COMMUNITY DEVELOPMENT DEPARTMENT REPORT

HEARING 11/6/2025
DATE: *Vacated from 3/20/2025 agenda;
continued from 10/2/25*
TO: Planning & Zoning Commission
FROM: Sonya Allen, Associate Planner
208-884-5533
sallen@meridiancity.org
APPLICANT: Brighton Corporation
SUBJECT: H-2024-0061
Apex Cadence (aka Pinnacle) – ALT,
MDA, PUD, PP, RZ, PS
LOCATION: 6575 S. Locust Grove Rd., in the NE 1/4
of Section 6, T.2N., R.1E. (Parcel
#S1406110355 & a portion of
#S1406110016)

H. Common Driveway Exhibits – NOT APPROVED

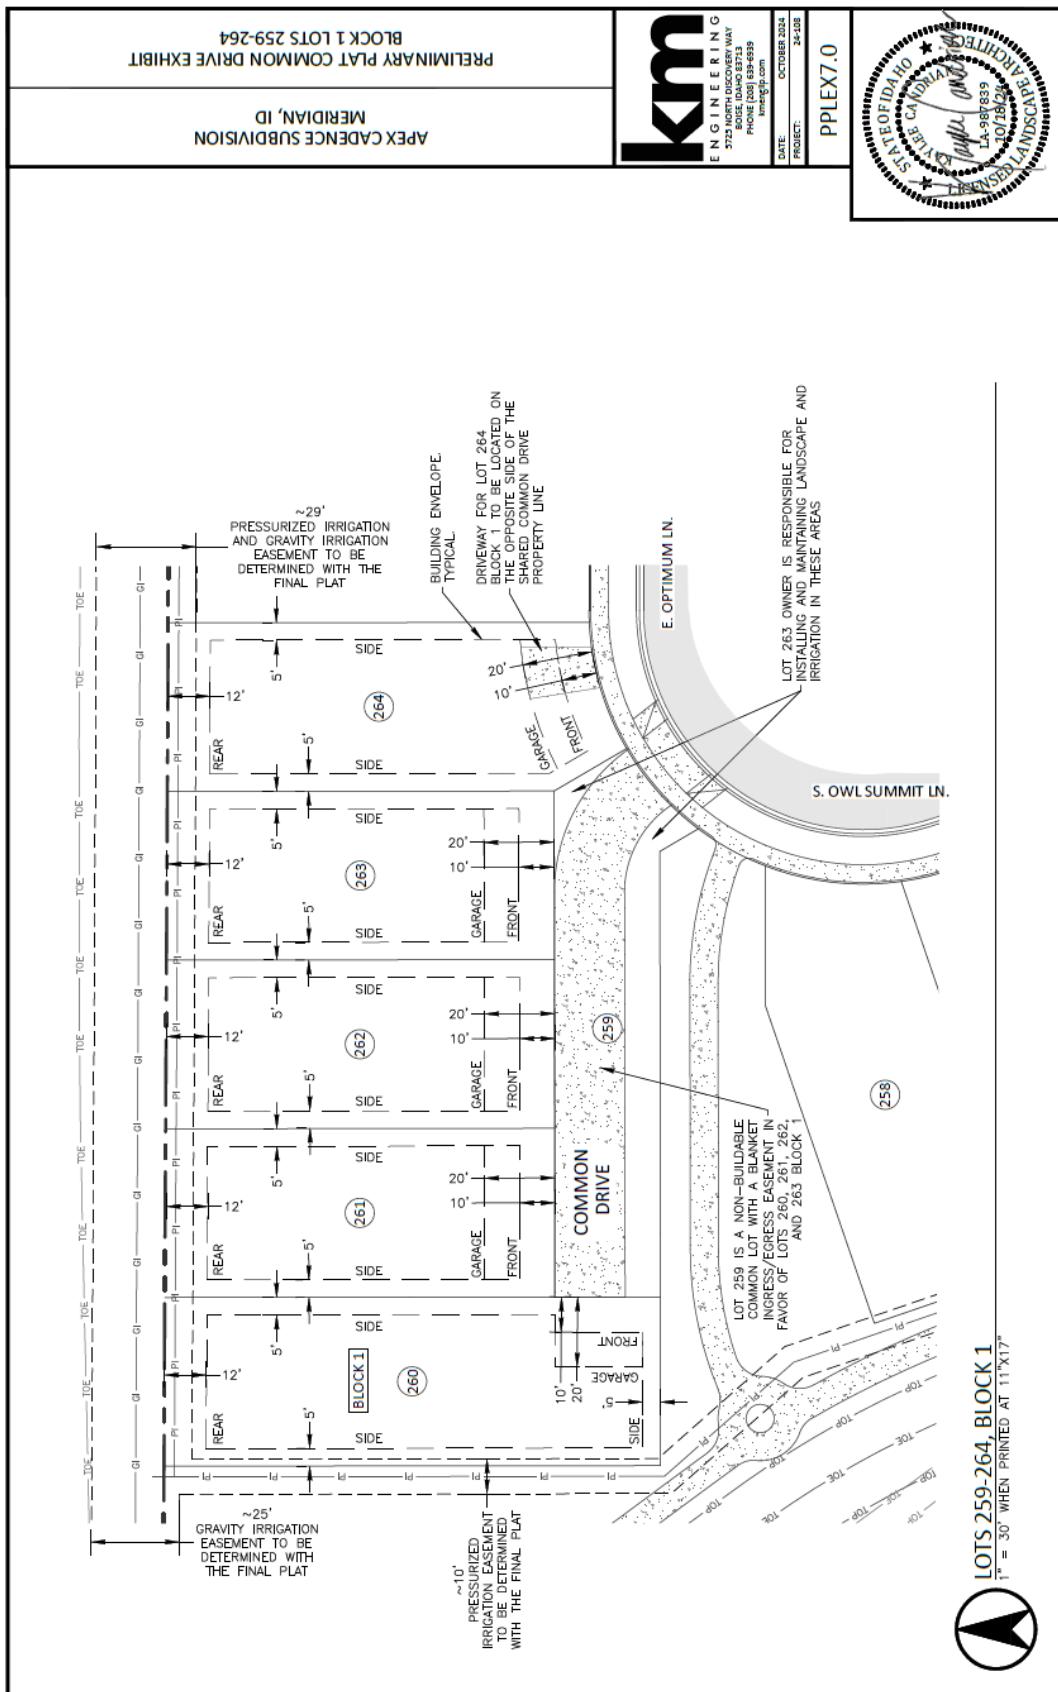
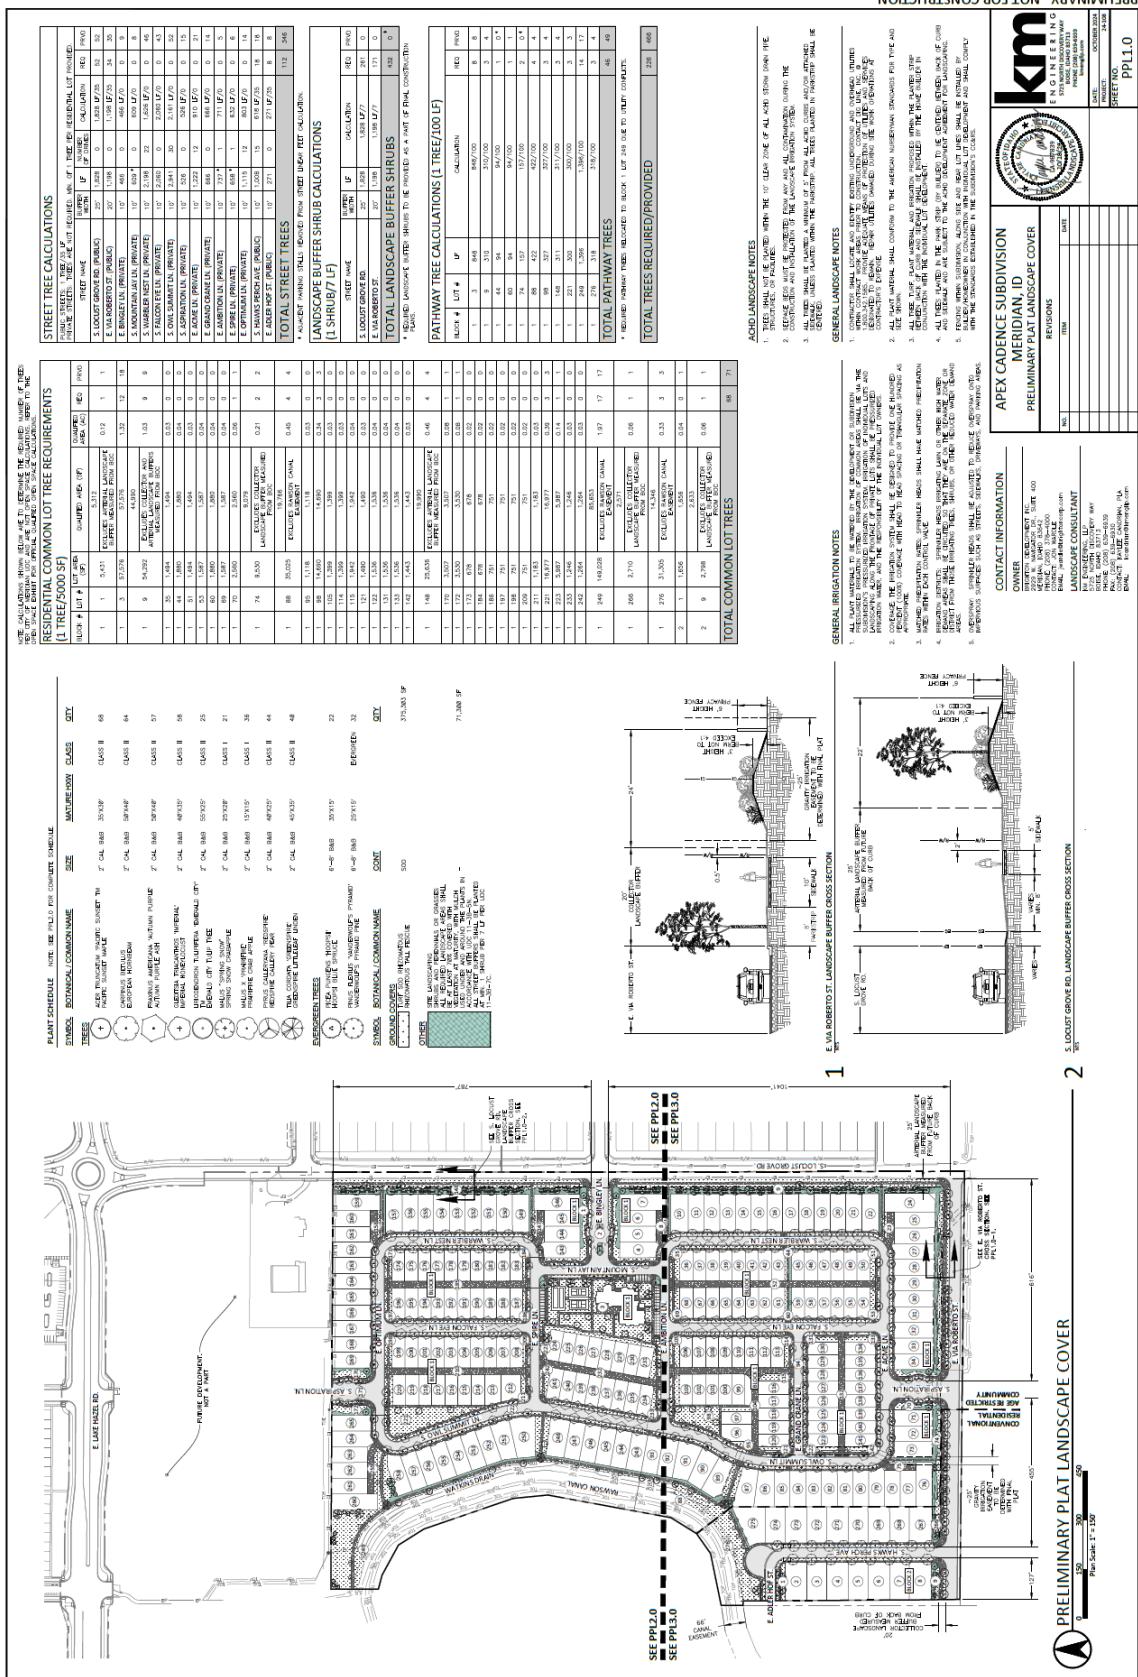
- Include the small triangle areas between the common driveways and adjacent building lots in the adjacent building lots; revise the plat accordingly. Provide a 28-foot inside and 48-foot outside turning radius in accord with UDC 11-6C-3D.6.

- v. Include the small triangle areas depicted on the landscape plan and common driveway exhibits between the common driveways and adjacent building lots in the adjacent building lots. Ensure the driveways provide a 28-foot inside and 48-foot outside turning radius in accord with UDC 11-6C-3D.6.

- g. The common driveways shall be constructed in accord with the standards listed in UDC 11-6C-3D and the revised common driveway exhibits in Section VII.H.

I. Landscape Plan & Fencing Plan (dated: October 2024)

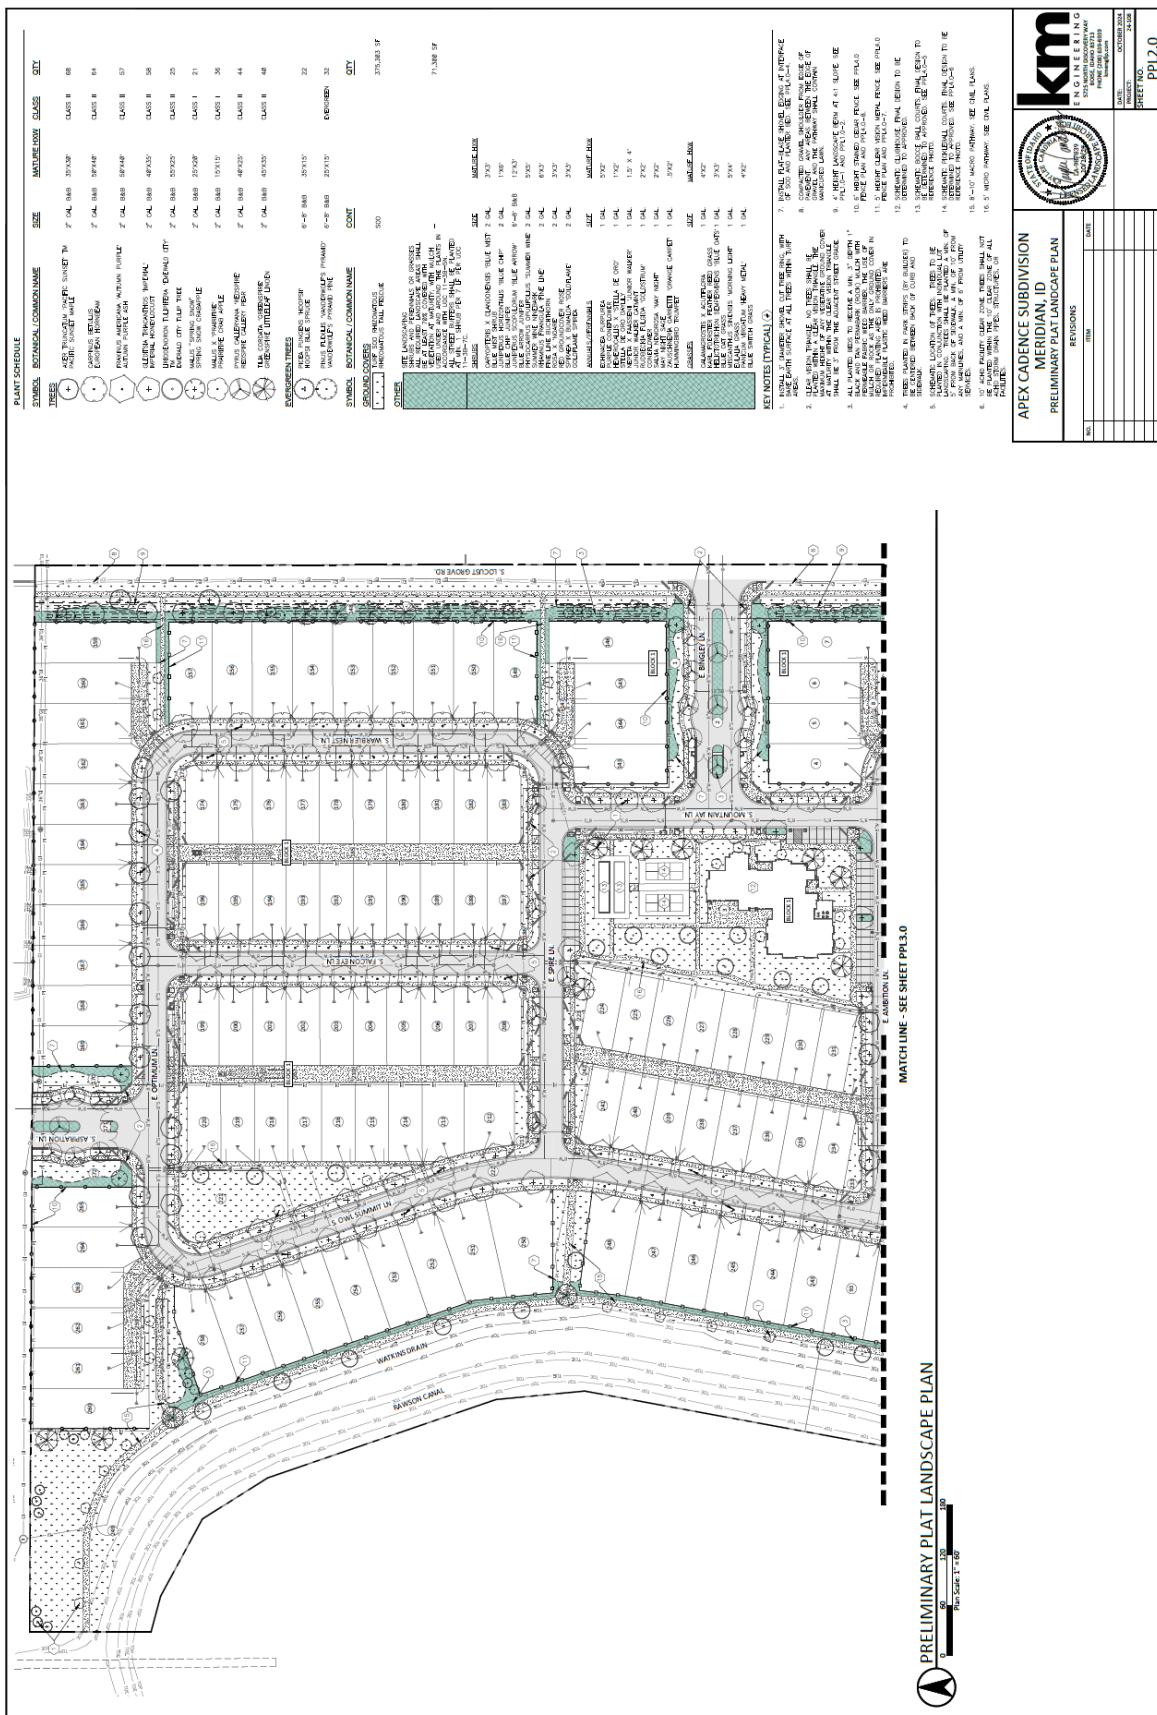
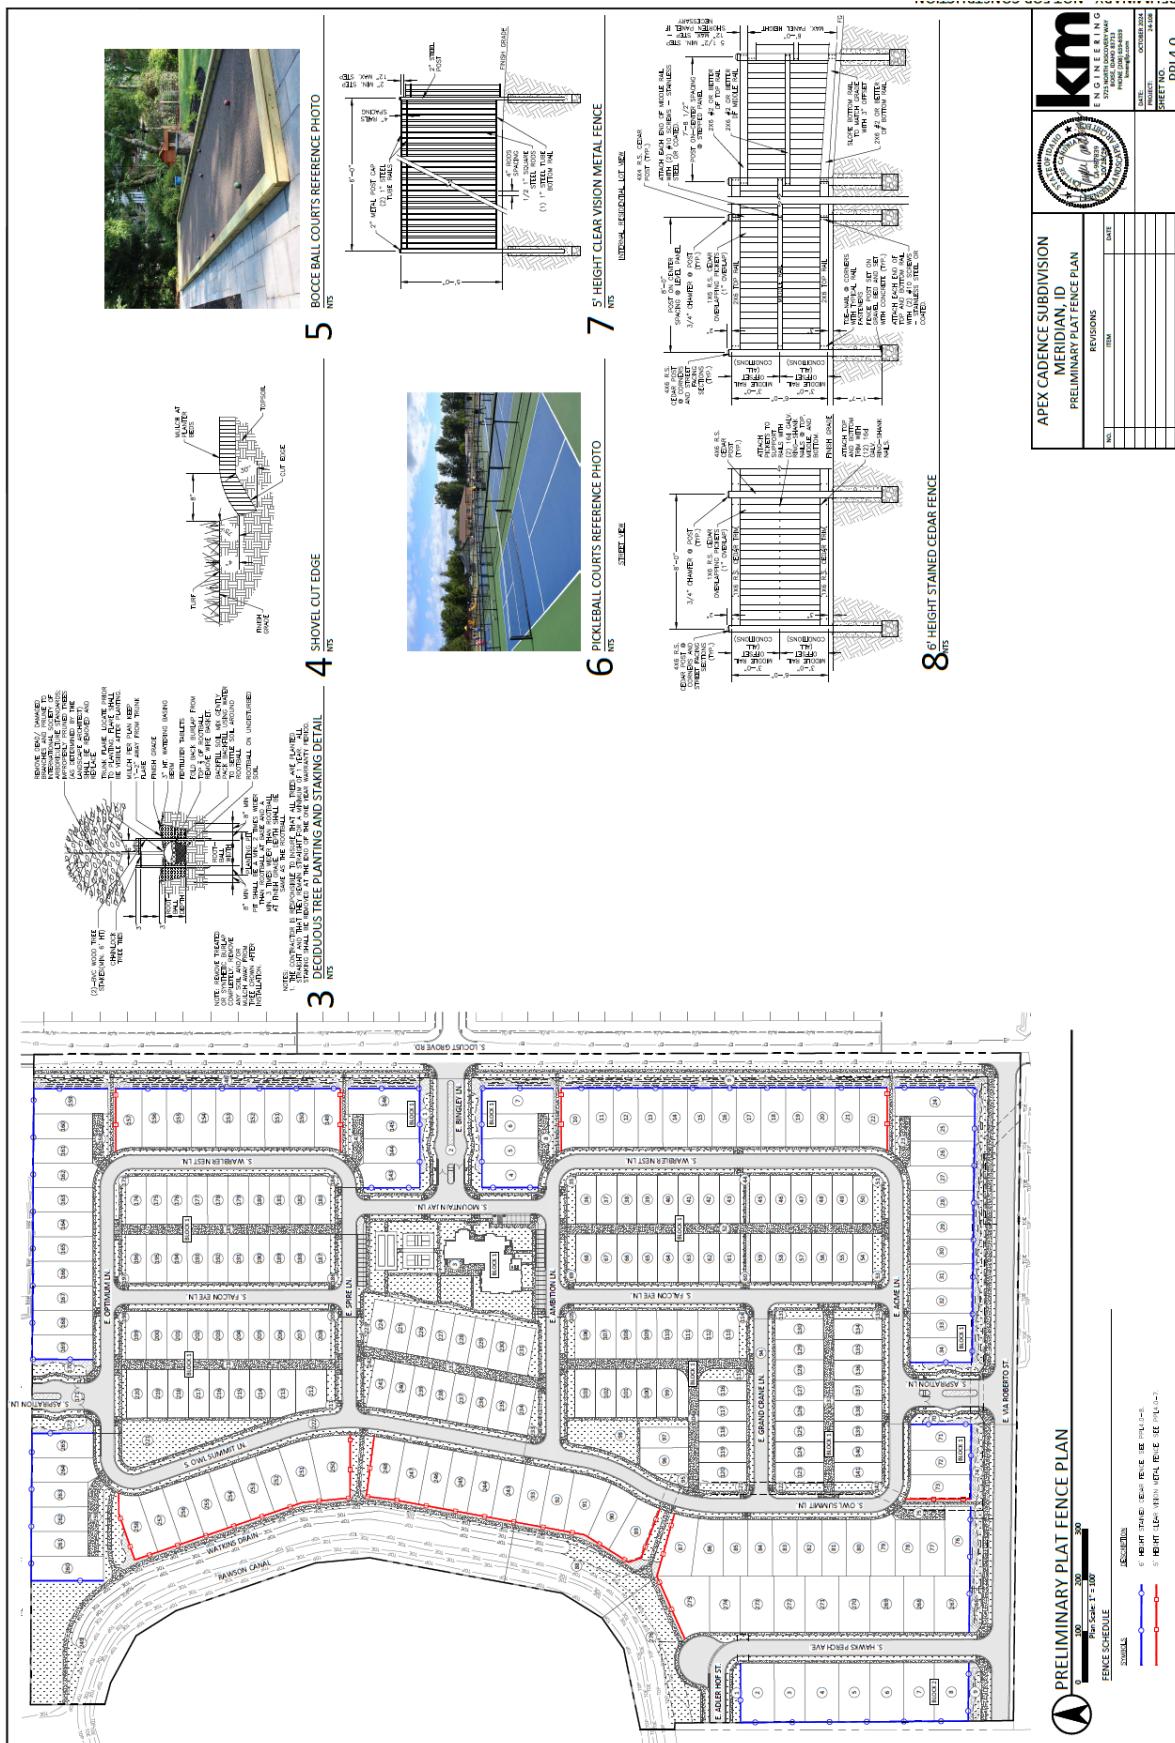
There are a few existing trees on the property along the Rawson Canal; **include mitigation calculations on the landscape plan in accord with the standards in UDC 11-3B-10C.5, as applicable.**

Landscaping is required within minimum 5-foot-wide landscape strips along each side of all pathways in accord with the standards listed in UDC 11-3B-12C. A minimum of one (1) tree is required per 100 linear feet of pathway with shrubs, lawn or other vegetive groundcover along pathways; **shrubs should be included in the planter strips/common areas along with vegetative groundcover.**

All fencing should comply with the standards listed in UDC 11-3A-7A. The landscape plan depicts a mix of 6-foot tall cedar fence and 5-foot tall clear vision metal fence. The developer is responsible for constructing fences abutting pathways and common open space lots to distinguish common from private areas; **fencing should be depicted on the landscape plan accordingly.**

- iii. Depict benches for seating by the sports courts (i.e. bocce ball and pickleball) in accord with UDC 11-3G-4D.5.
 - iv. Depict a minimum 10-foot-wide multi-use pathway along the Rawson Canal, including along the cul-de-sac to the west boundary of the site alongside E. Adler Hof St., in Lots 88 and 276, Block 1 in accord with UDC 11-3A-8G and the Pathways Master Plan.

- v. Depict a 10-foot-wide detached sidewalk/pathway within the street buffer along S. Locust Grove Rd.
 - vi. Include the small triangle areas depicted on the landscape plan and common driveway exhibits between the common driveways and adjacent building lots in the adjacent building lots.

- ix. Include tree mitigation calculations on the landscape plan in accord with the standards in UDC 11-3B-10C.5, as applicable.
 - x. Depict a mix of trees, shrubs and vegetative groundcover along all pathways in accord with the standards in UDC 11-3B-12C.
